Re: Jack Ward and Christina O'Neill
26 Hudson River Lane
Garrison, New York

To: The Planning Board
Re: Wildrick application: 28-30 Hudson River Lane w/ James Hartford of River Architects c/o Ms. Cheryl Rocket
Date: March 31, 2022

Re: Proposed Residence, 28-30 Hudson River Lane
27.8 Spaces Project No. 22013

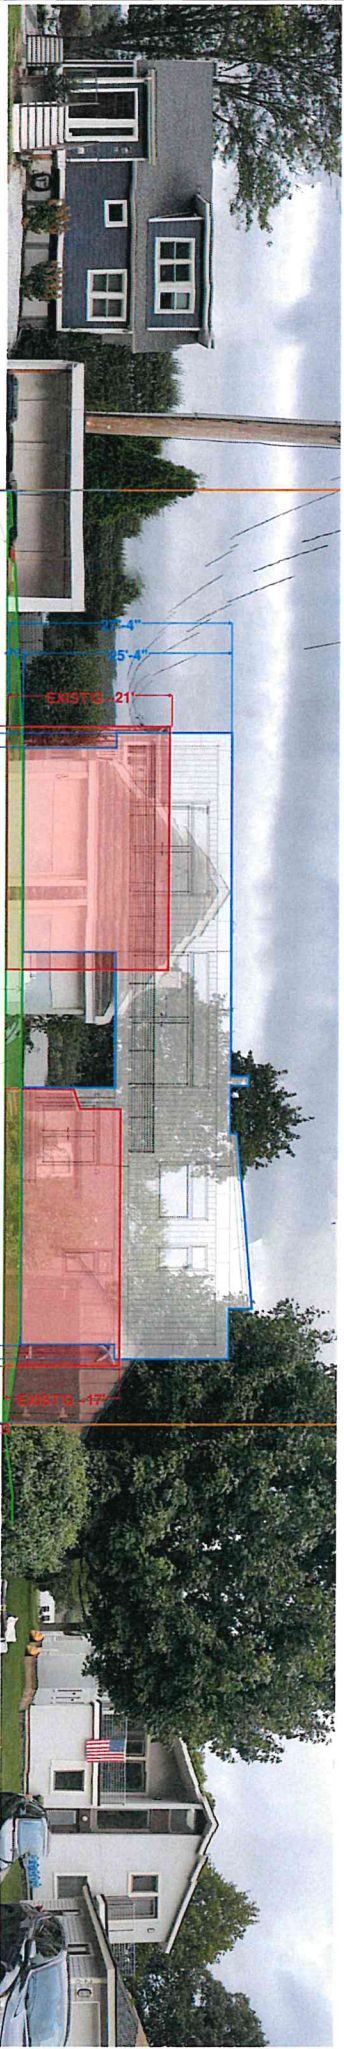
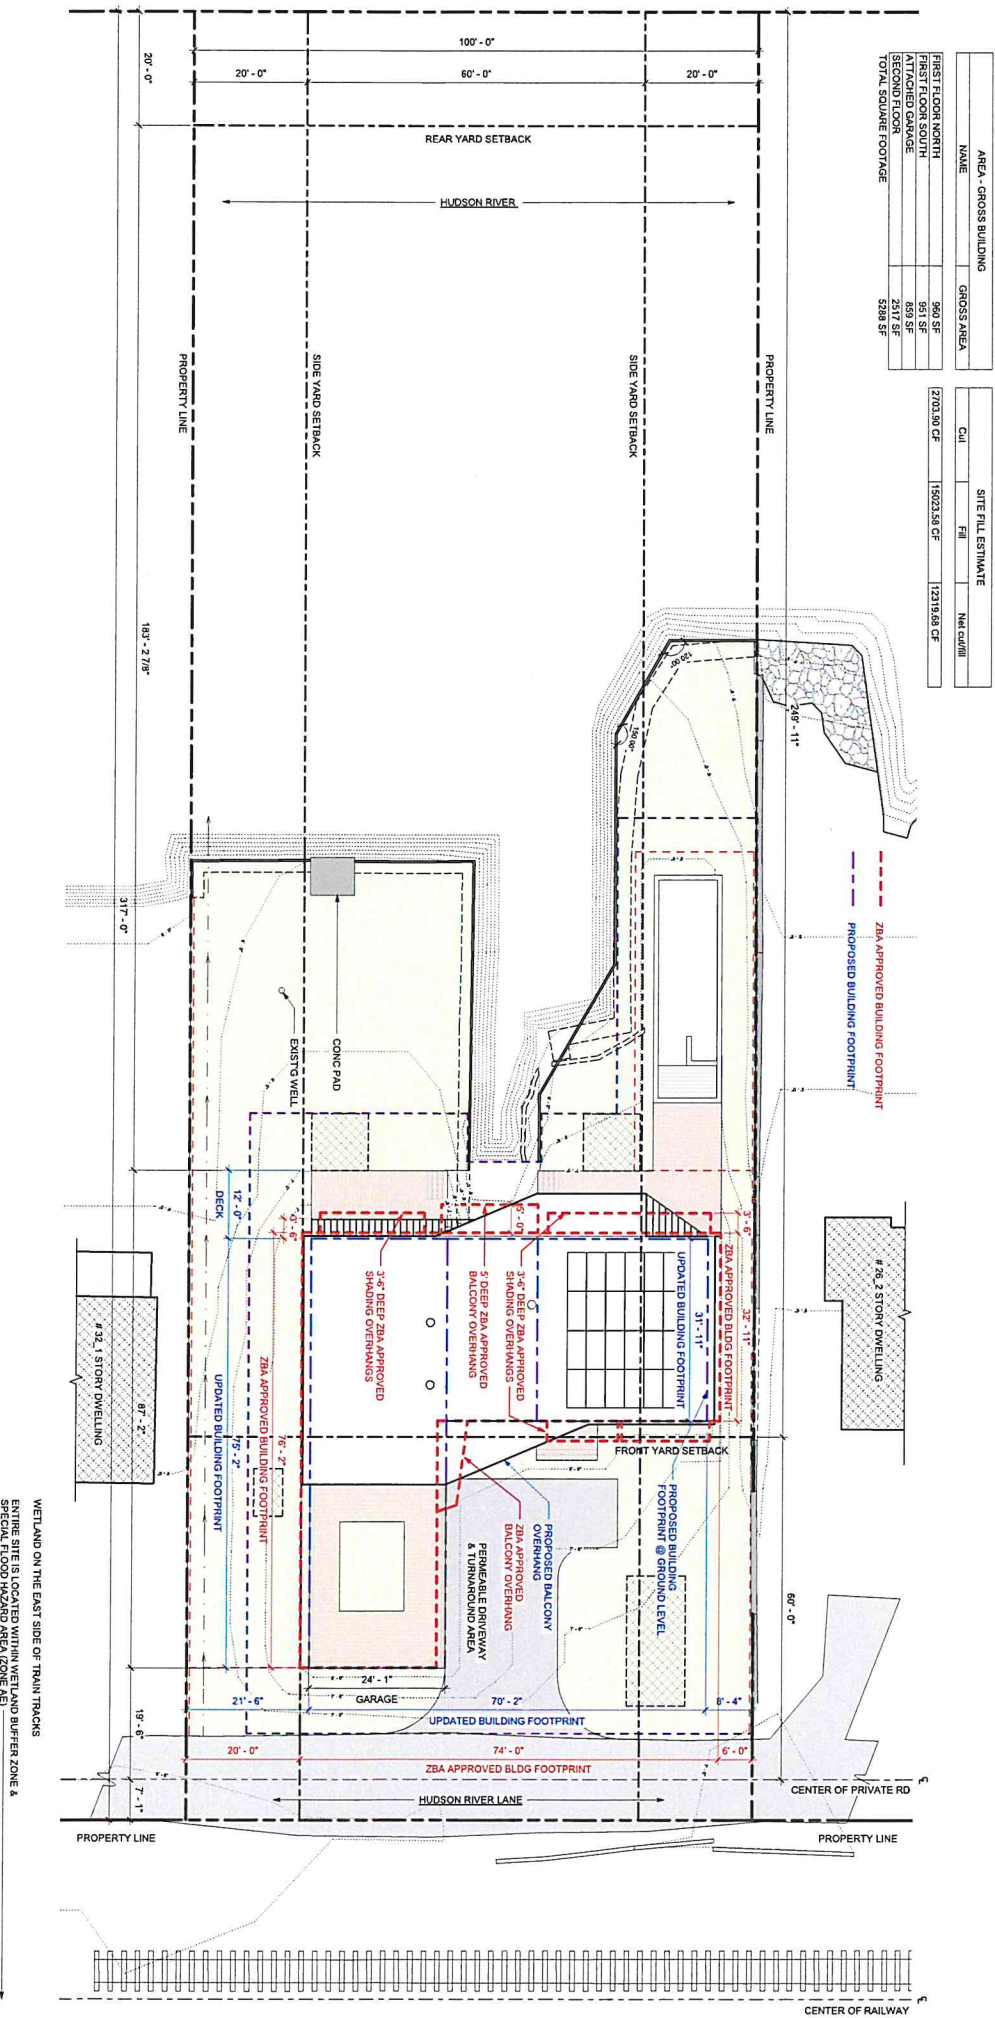
The image has been altered and is more of a stretched photo montage creating the illusion of three times the distance between homes. Please note the photos of the properties in present-day form, in comparison. Also in this montage, the applicant does not correctly locate the proposed house. The application plan shows the north face directly on the line of the existing house [28], yet River Architects presents a photo montage showing this side pushed further away from our house than indicated on his site plan. The montage and the plan should be identical.

This appears to be another misrepresentation by the applicants. Note the glaring discrepancy between the garbage enclosure in his presentation vs. the photo of the garbage enclosure; it bears no resemblance. Also, there are double images of our kayak and our car. Why wasn't this elevation drafted true to form, instead of presenting a collage that clearly misrepresents scale and distance? In the November meeting, chairperson Kim Conner directed a question addressing her concern for the size of the proposed versus the existing, smaller houses. Mr. Hartford presented this image.

SITE PLAN PROPOSED

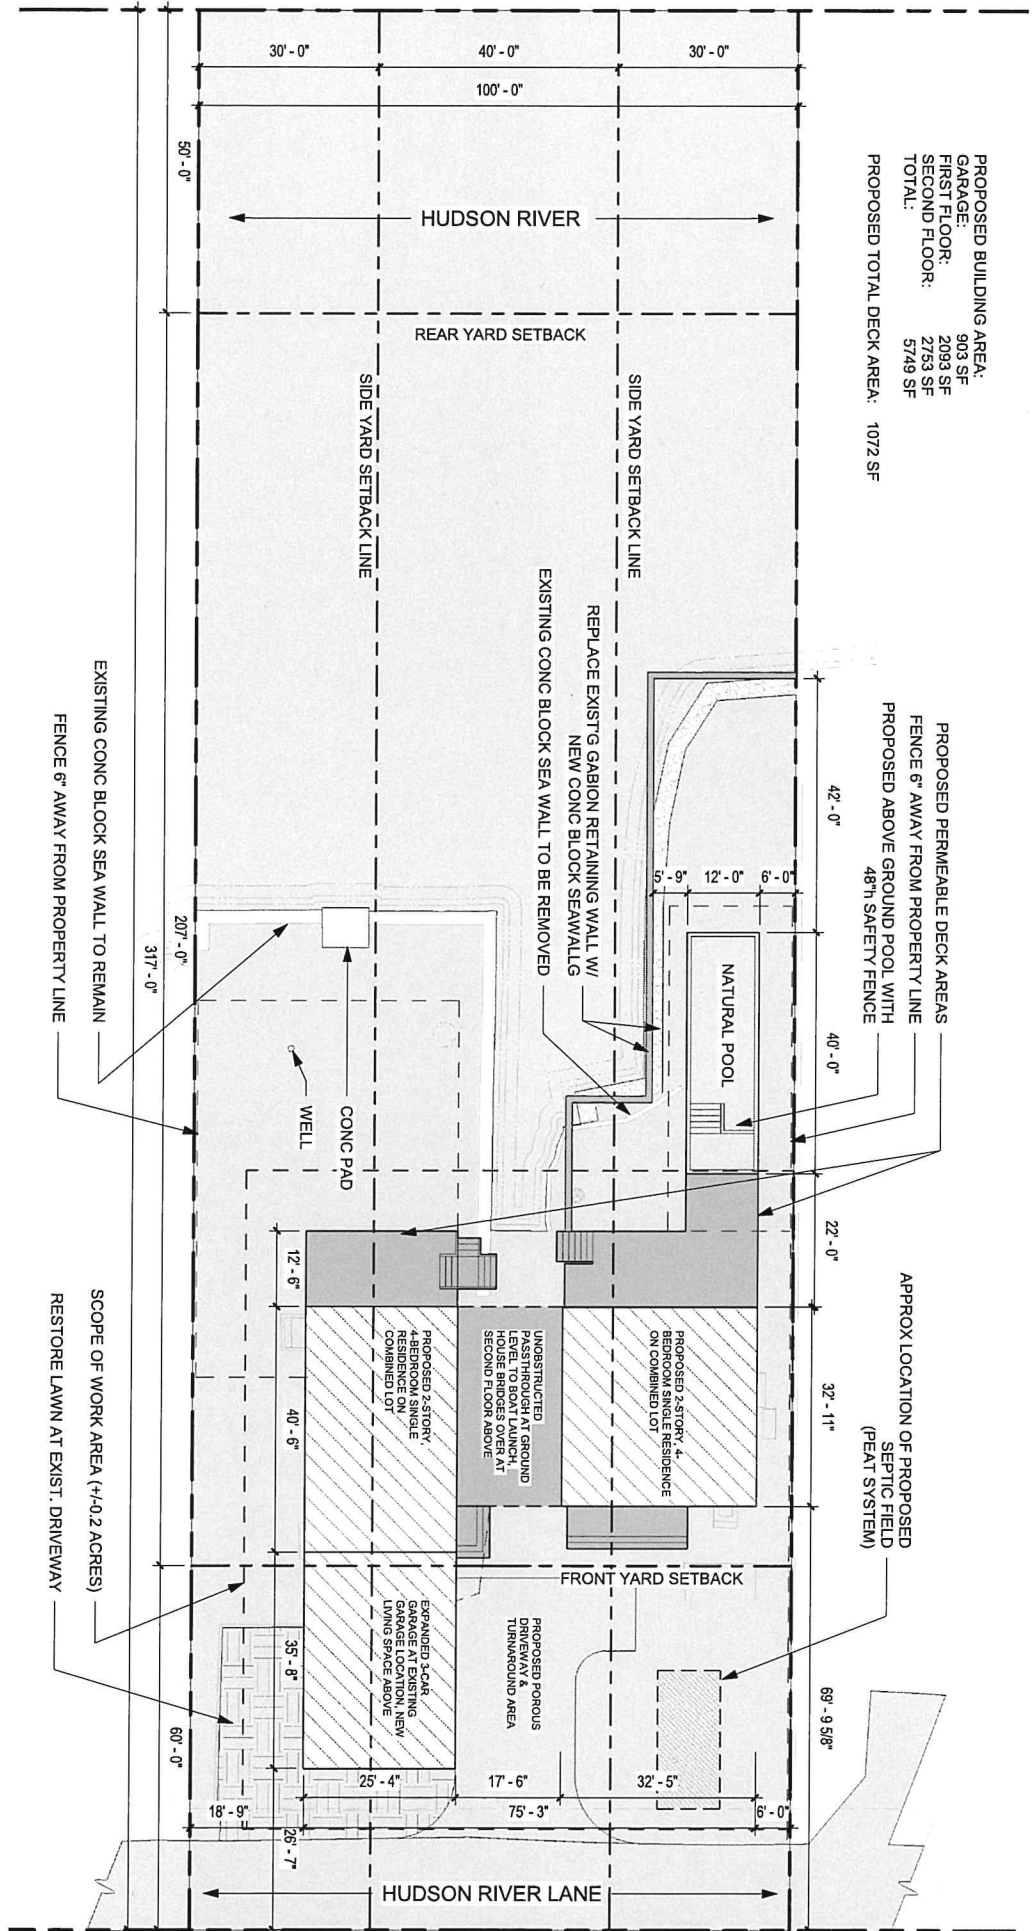
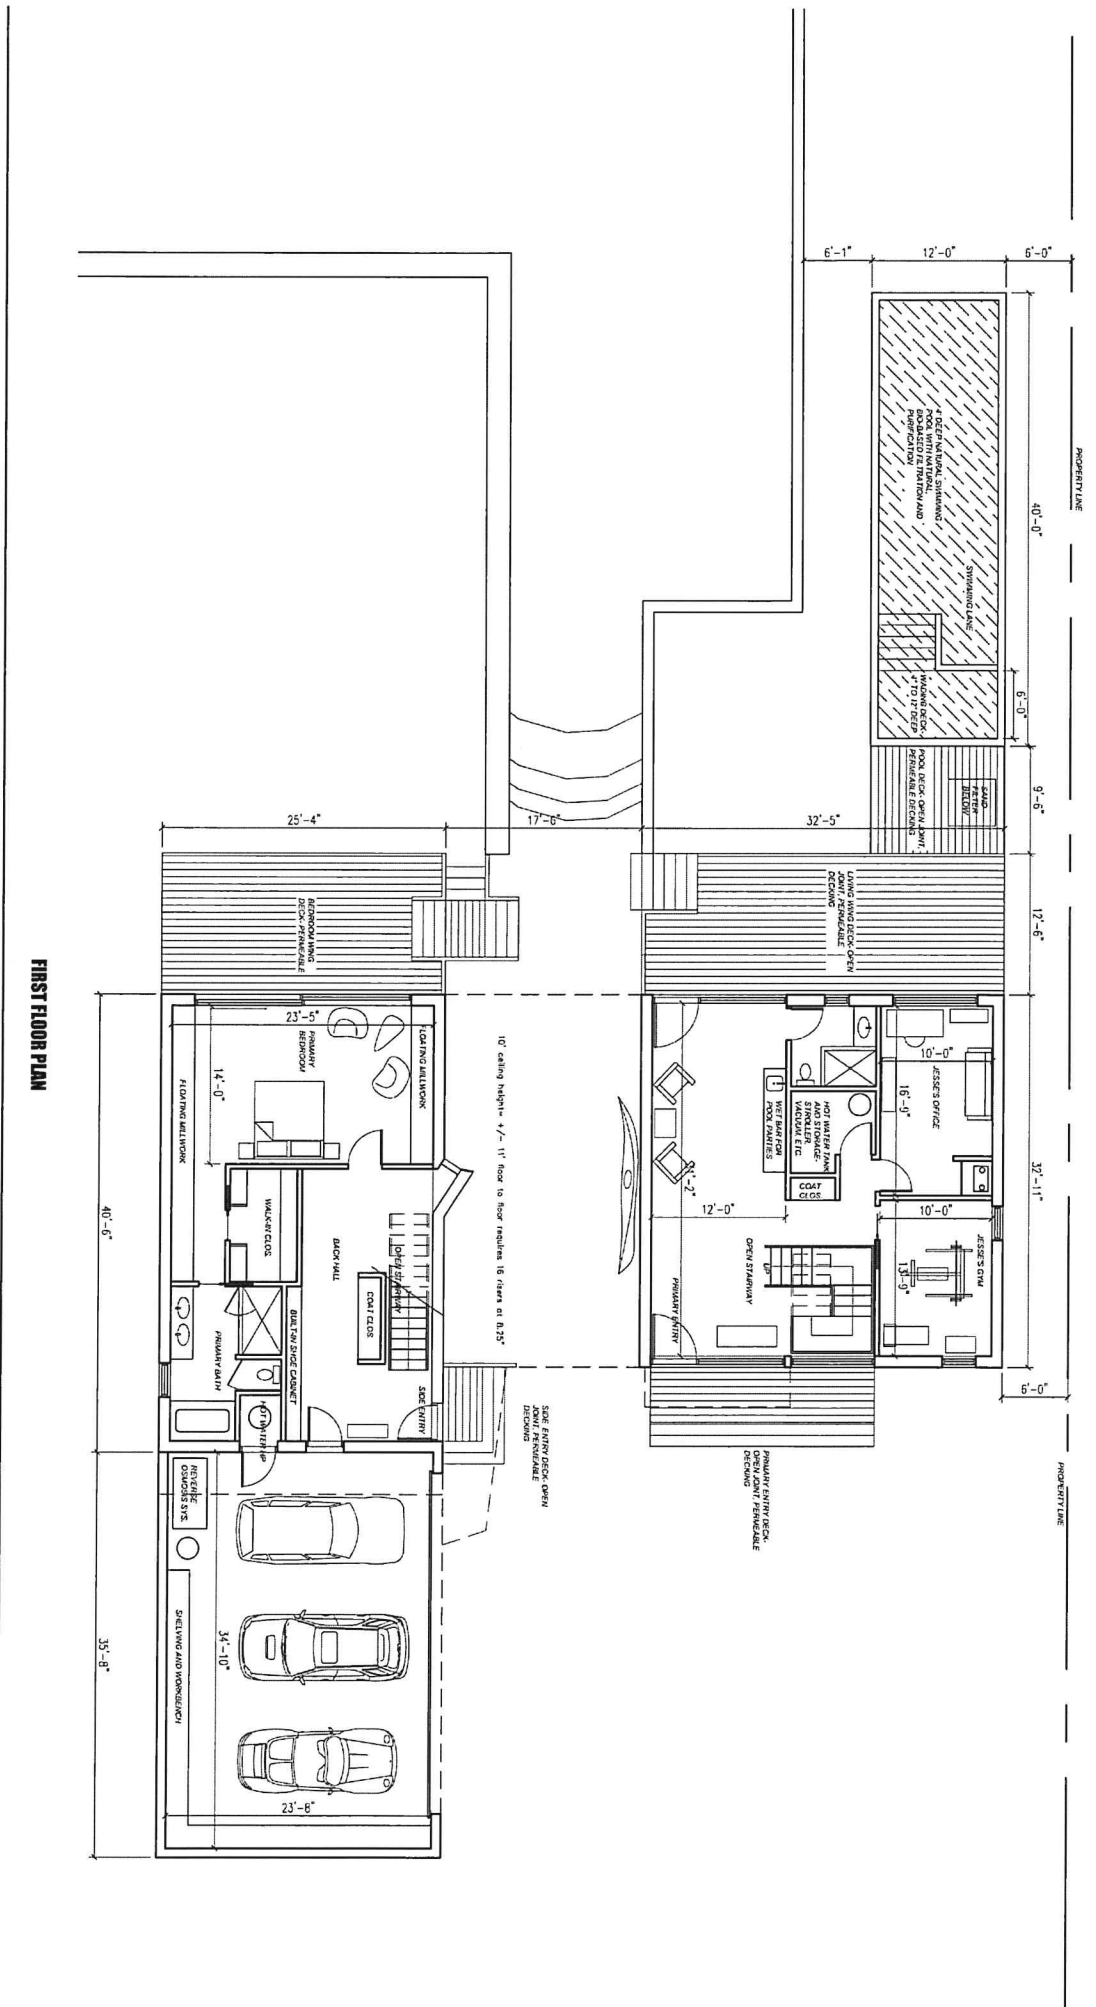
The plans approved by the Zoning Board back in July of 2021 have changed and different plans have now been submitted to the Planning Board. We have serious concerns as to what will be built, as the submissions seem to change regularly. Based on that, we ask the Board to review the current submittal and any future submittal against what was approved by the Zoning Board to determine whether new variances are required. Specifically, our review of the overlay plan prepared by the applicant shows the following deviations: increase of stated total impervious coverage square footage from 5890 to 6469 which may trigger a new variance under 175-23b2; the addition of an 8 ft front upper deck extending out on lot #28 west facing river; the change (resulting in an increase) of the façade on the north side of the home on lot #28 from a flat surface to an overhang extension from the second floor; and the change and increase of a balcony and overhang on the second story east facing section of house. (ZBA submission attached for comparison)

The site plan as presented by River Architects, however, indicates 38.7%. Compared to my calculations, their calculations are low by 2.9%. If I had to offer an educated guess as to the origin of the discrepancy, their calculations are consistent with the result if you mistakenly omit the square footage covered by the second story area that bridges the two first floor components.
